Prime Contract Potential Change Order #003: PR 03 Precast and Roof Drain Updates (Material)

PROPOSAL REQUEST 03 (PR-03)

PROJECT NAME: St. Francis Fire & City Hall

PROPOSAL REQUEST 04 (PR-04)

B. Sheet M4-21

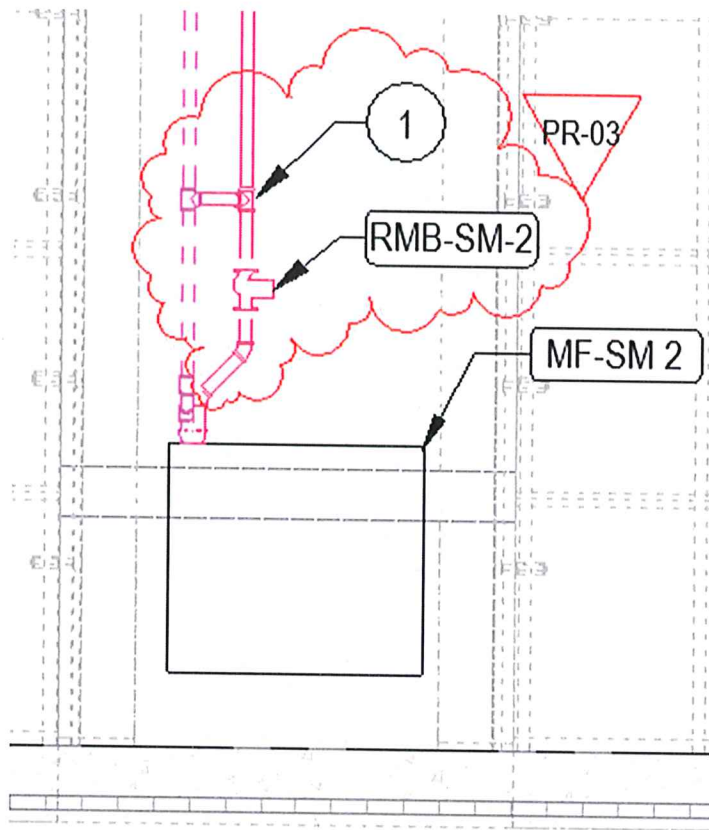
1. Added pump RMB-SM-1 and bypass piping. Both are typical for both RMB-SM-1 and for RMB-SM-2 (both snow melt zones).

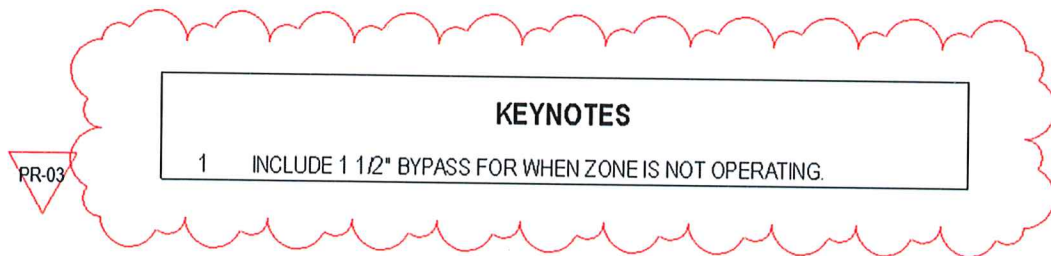
2. Added keyed note for bypass piping.

C. Sheet P2-10

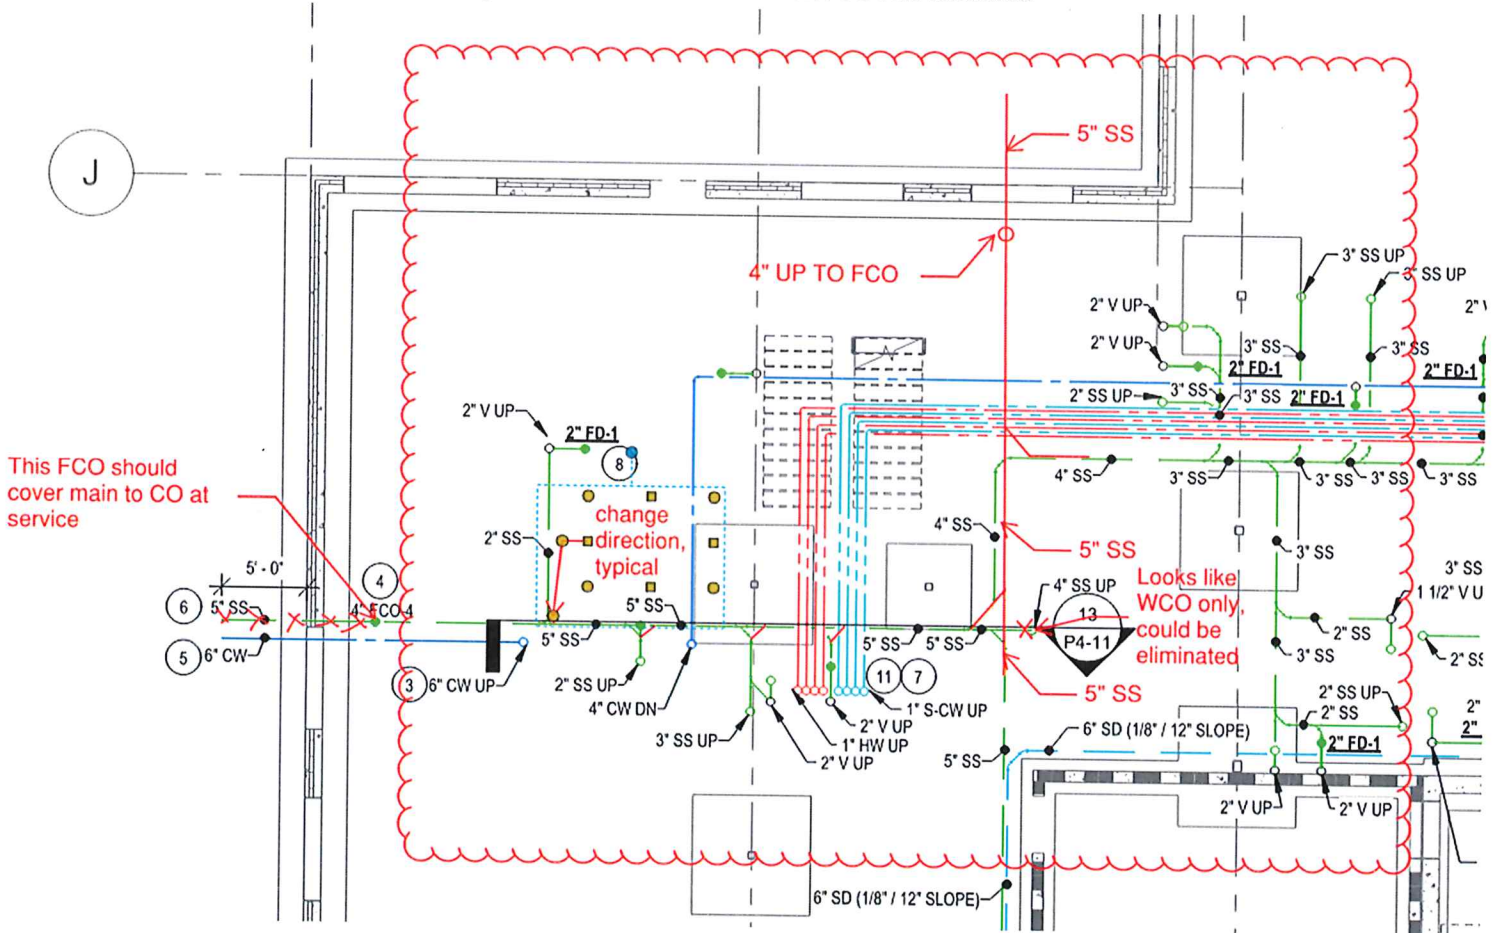
- Sanitary sewer service shall leave the building to the East below VEST 152 instead of originally shown under GENERATOR 155. Add 5" Sanitary Sewer main piping East as shown. Add 4" SS piping up to FCO-4 before exiting the building foundation. Revise section of 4" SS piping running East-West under CORRIDOR 126 to be 5".
- Omit 4" SS piping up to WCO in CORRIDOR 126. Omit all sanitary piping South of 4" FCO-4 in CITY ADMIN 123.
- Change wye fitting directions as shown for new service location.
